Hope Creek Generating Station
Renewed Facility Operating License No. NPF-57
NRC Docket No. 50-354

Subject: Response to Request for Additional Information, Re: Adopt 10 CFR 50.69 LAR

Response to Request for Additional Information - Application to Adopt Title 10 of the Code of Federal Regulations 50.69, "Risk-Informed Categorization and Treatment of Structures, Systems and Components for Nuclear Power Reactors"

Figure 5c-1: PRAQUANT and FRANX Convergence by Decade

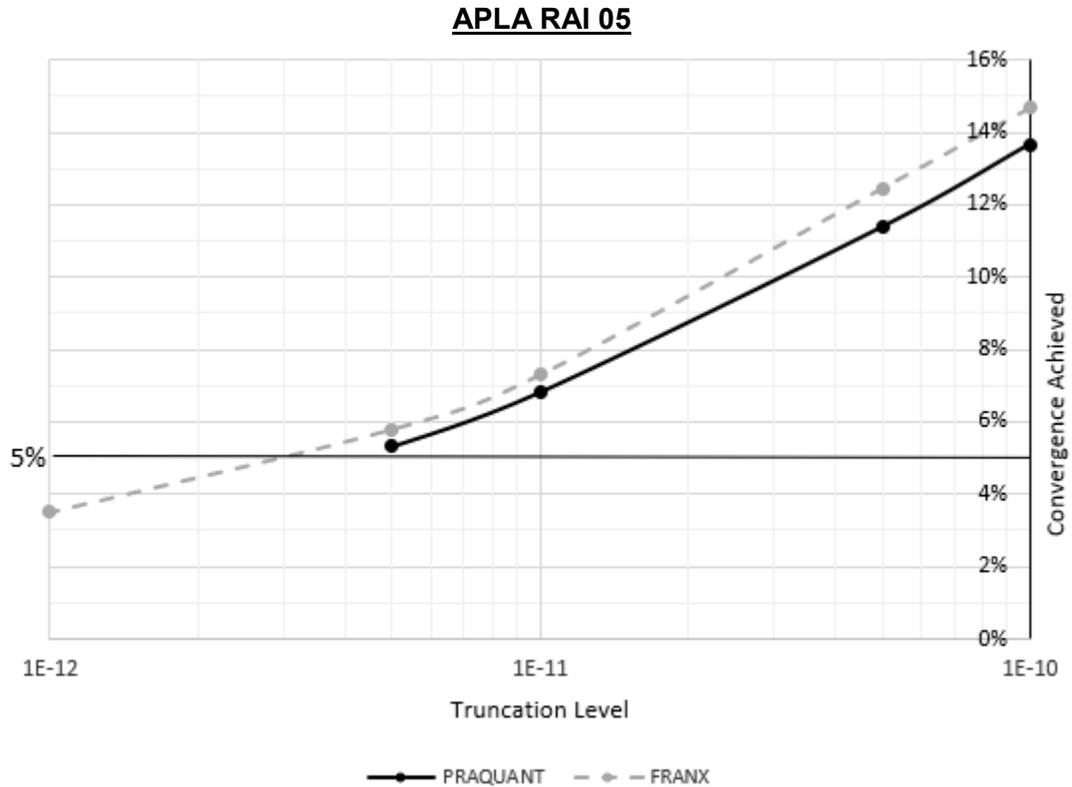
- i. Provide the actual LERF convergence value achieved.
- ii. Provide justification, such as a sensitivity study, that using a truncation value that does not achieve convergence does not impact the results of the 10 CFR 50.69 categorization process.

Table 5c-1 shows the PRAQUANT and FRANX Fire LERF calculations over four decades, to demonstrate that the model reaches less than 5% convergence between the 1E-12 and 1E-13 decades. The 1E-13 truncation quantification results for PRAQUANT are unknown due to software limitations, so convergence numbers are shown for the 1E-10 to 1E-11, 5E-11 to 5E-12, 1E-11 to 1E-12 and 5E-12 to 5E-13 decades for both methods, and the 1E-12 to 1E-13 decade for FRANX. Figure 5c-1 graphically maps the truncation decade to the convergence achieved for both PRAQUANT and FRANX for additional clarity. Note that the lines present on Figure 5c-1 are not formulaic, but instead simply connect the points of the graph for improved visualization.

Table 5c-1: PRAQUANT vs. FRANX Truncation Analysis				
Truncation Decade	PRAQUANT Result (/yr)	PRAQUANT Convergence %	FRANX Result (/yr)	FRANX Convergence %
1E-10	5.58E-06	13.6%	5.59E-06	14.7%
5E-11	5.84E-06	11.5%	5.86E-06	12.5%
1E-11	6.34E-06	6.8%	6.41E-06	7.3%
5E-12	6.51E-06	5.2%	6.59E-06	5.8%
1E-12	6.77E-06	⁽¹⁾	6.88E-06	3.5%
5E-13	6.85E-06	N/A	6.97E-06	N/A
1E-13	⁽¹⁾	N/A	7.12E-06	N/A

Figure 1: GMRS and SSE Response Spectra for HCGS
From Reference [4]

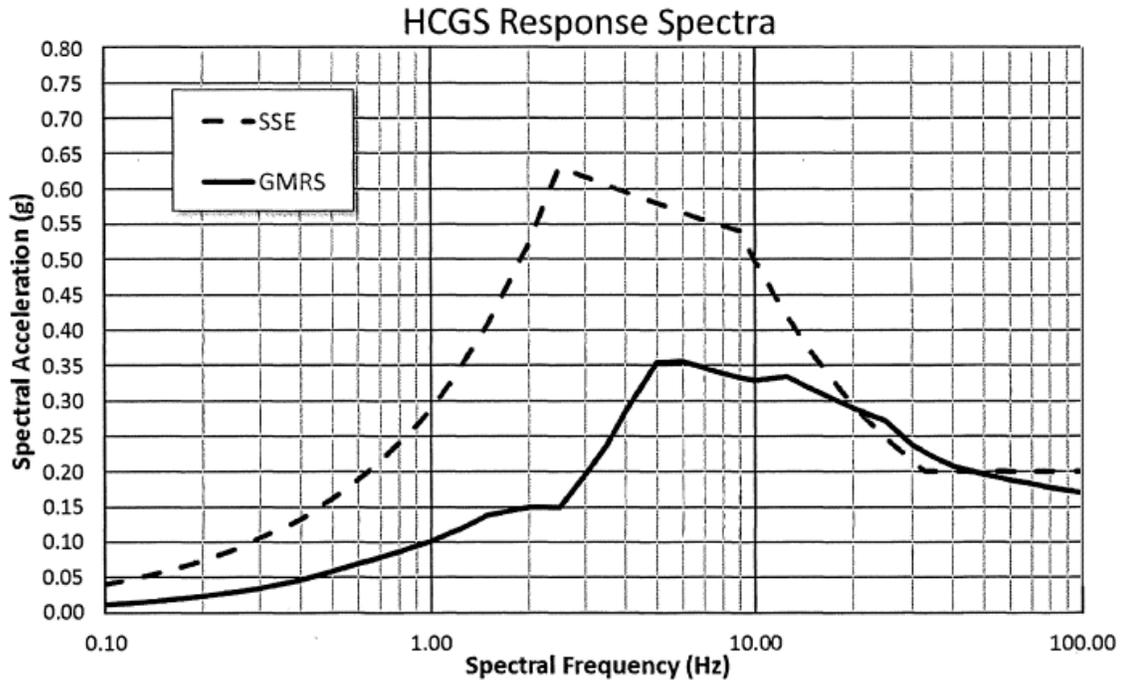
Section 3.2.3, “Seismic Hazards,” of the enclosure to the LAR states that “small percentage contribution of seismic to total plant risk makes it unlikely that an integral importance assessment for a component, as defined in NEI 00-04, would result in an overall HSS determination...” Section 2.2.2 of the EPRI report identifies the contribution of seismic to total plant risk as a basis for the use of the proposed alternate seismic approach. Further, the insights in the EPRI report are derived from the full spectrum of the seismic hazard (i.e., the entire hazard curve). The LAR does not provide information to support the claim that the plant-specific seismic risk is a small percentage contribution to total plant risk and thereby, the applicability of the proposed alternate seismic approach to the licensee.

Justify that the plant-specific seismic risk is low relative to the overall plant risk such that the categorization results will not be significantly impacted to support the applicability of the proposed alternate seismic approach.

For the HCGS site, the GMRS-to-SSE comparison taken from the LAR and shown below in Figure 1 demonstrates that the GMRS is well below the SSE between 1 Hz and 10 Hz which qualifies it as a Tier 1 plant under the criteria in the EPRI report. These criteria are similar to the grading process used in EPRI 1025287 (Reference [2]) for the Fukushima 50.54(f) letter responses and in NEI 12-06 (Reference [3]) for the Mitigation Strategy Assessment. This comparison also confirms that the expected seismic risk at HCGS would be very low. Structures, systems, and components (SSCs) designed to the SSE level would have significant seismic capacity margins beyond the GMRS seismic level, which would result in high median capacities, and therefore would produce low seismic risk values.
